# Product Change Notification

## 111385 - 02

**Change Notification #:** 111385 - 02  
**Change Title:** Intel® Integrated RAID Module  
RMS25PB080, RMS25PB040, RMT3PB080,  
RMS25CB080, RMS25CB040, and  
RMT3CB080, PCN 111385-02, Product  
Design, Product Design, Heatsink Update,  
Attention Document Update, Quick Start  
User's Guide Update, Board-to-board  
Connector for Battery Backup Unit and  
RAID Maintenance Free Backup Unit  
Update, Firmware Update, Module Rework,  
Reason for Revision: Update Post Change TA  
**Date of Publication:** July 12, 2012

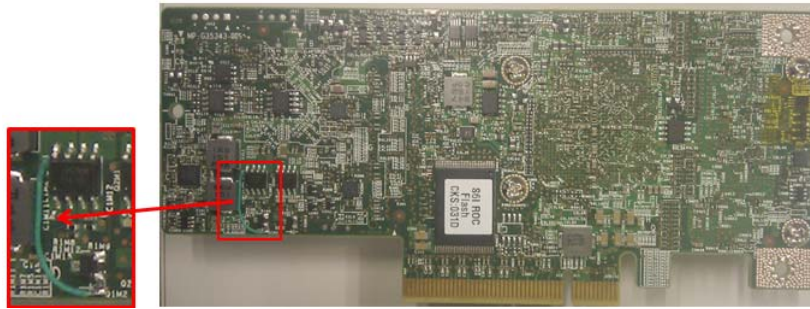
The heatsink on the Intel® Integrated RAID Module RMS25CB080, RMS25CB040 and RMT3CB080 is being redesigned with a change to the fins. This will eliminate the possibility of the heatsink making contact with a PCI-e adapter when installed close to the module in following Intel® Server System:

Jumper wire on Intel® Integrated RAID Module RMS25PB080, RMS25PB040 and RMT3PB080:

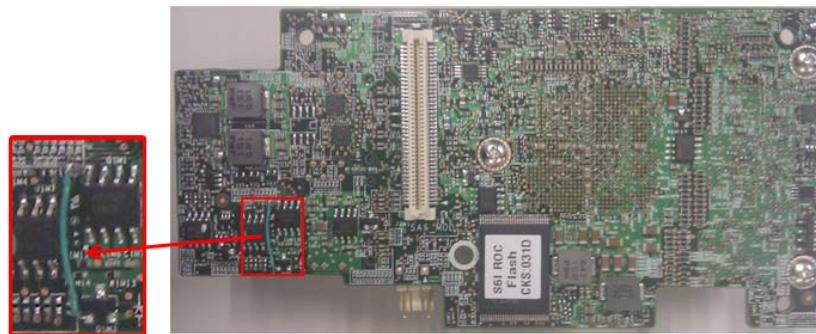
A jumper wire is being added during production to reliably support the Intel® RAID Smart Battery AXRSBBU9 and the Intel® RAID Maintenance Free Backup Unit AXRMFBU2 cache backup solution.
